**Northeast
Nuclear Energy**

Millstone Nuclear Power Station, Unit No. 3
Modification of Proposed Revision to Technical Specification - Spent
Fuel Pool Rerack (TSCR 3-22-98)

**Millstone Nuclear Power Station, Unit No. 3
Response to Requests for Additional Information
Spent Fuel Pool Rerack (TAC No. MA5137)**

Response to Requests for Additional Information
Spent Fuel Pool Rerack (TAC No. MA5137)

**Additional Questions Regarding Heavy Load Handling
Rigging Configurations - Exhibits 6.5.1 through 6.5.5**

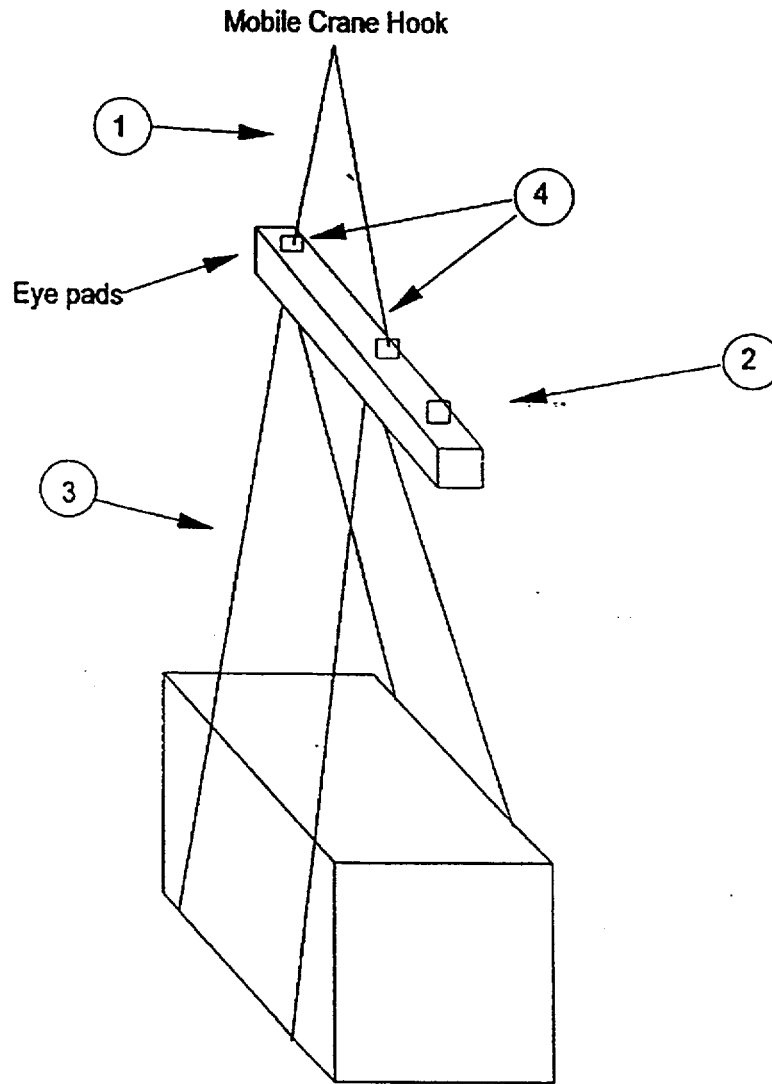
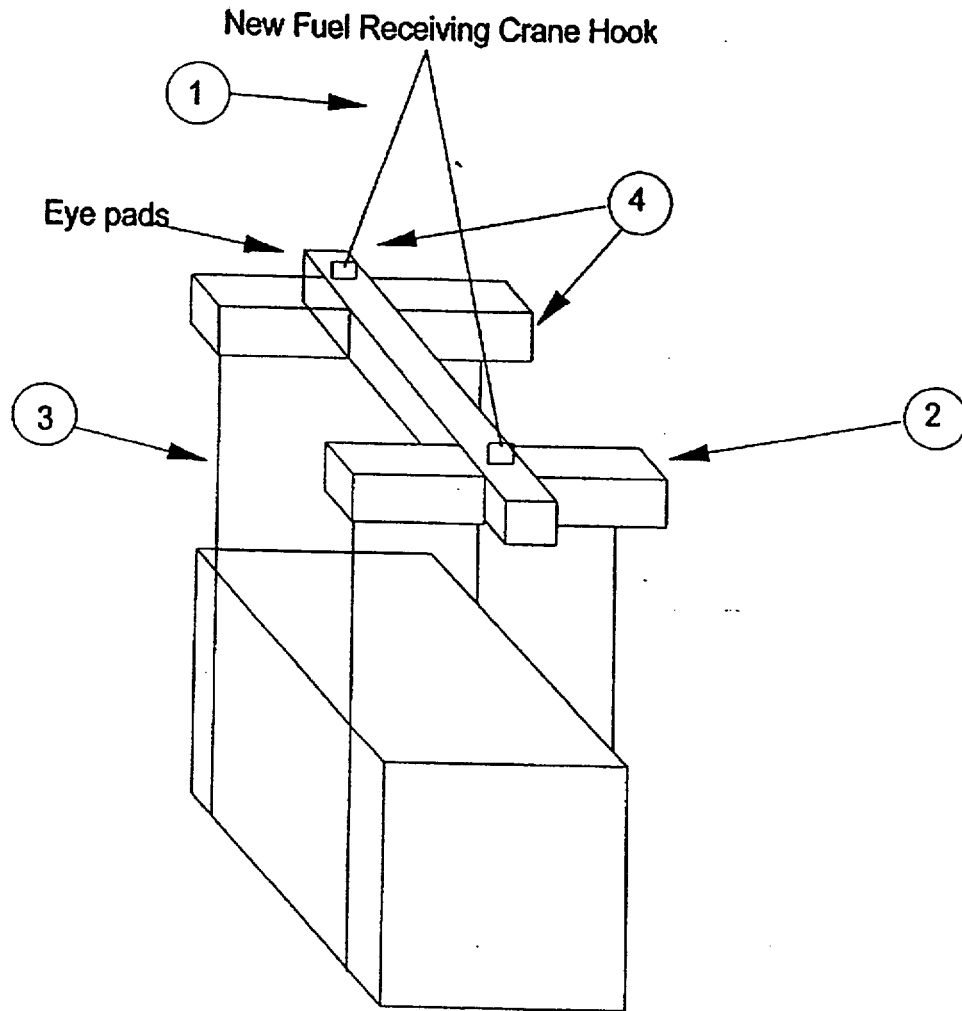
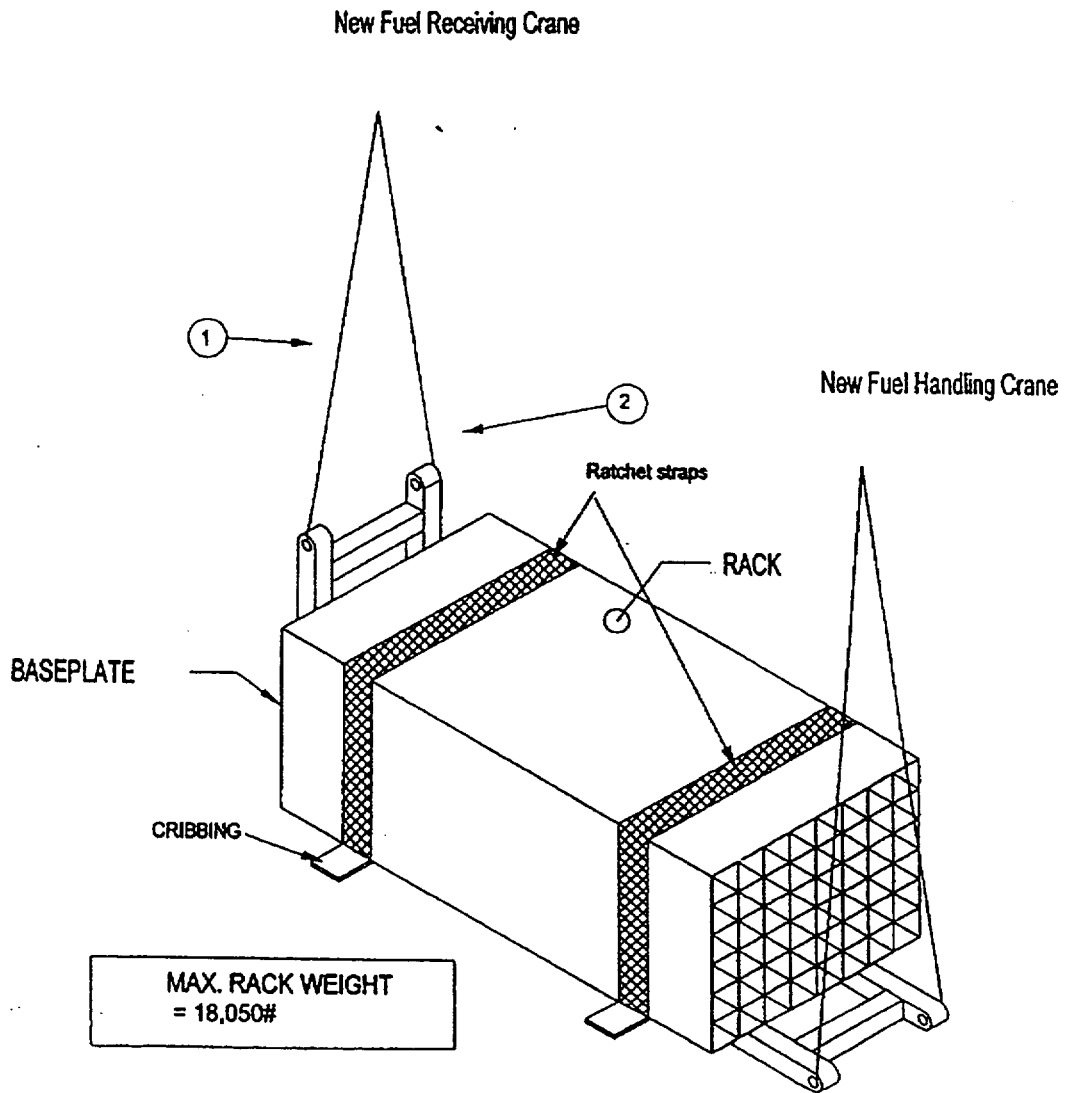
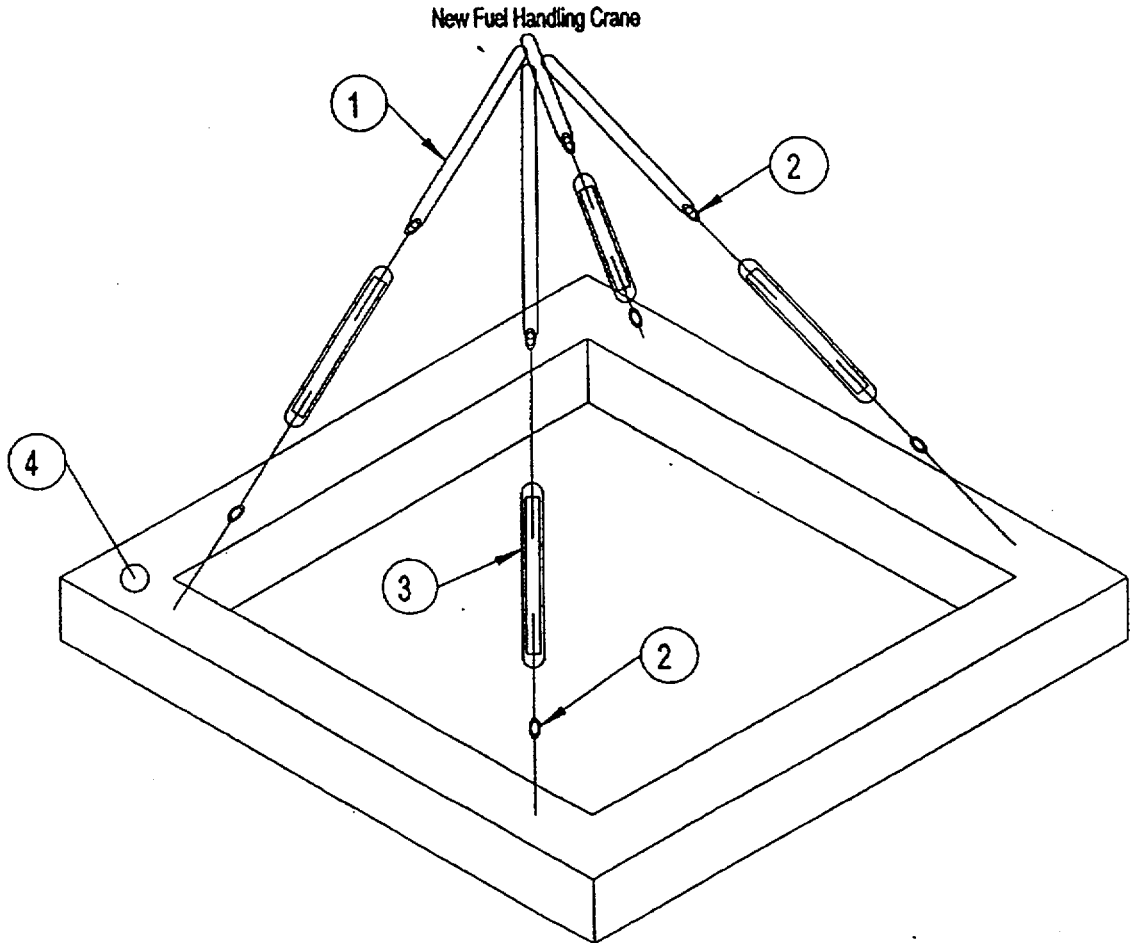
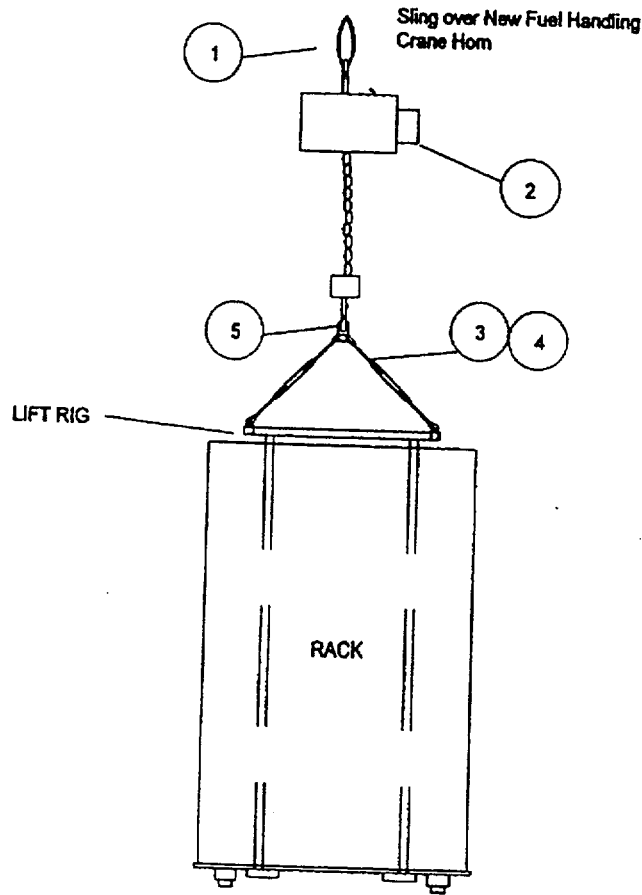
- 1. Regarding lifting devices described in Section 3.3 of the Holtec Licensing Report, provide additional detail with respect to the use of installed equipment and its interface with vendor supplied lifting devices, and the design and qualification standards applied to vendor supplied lifting devices.**

6. Clarify the discussion at the beginning of Section 10.5 of the Holtec Licensing Report regarding upending operations.

Response

Response
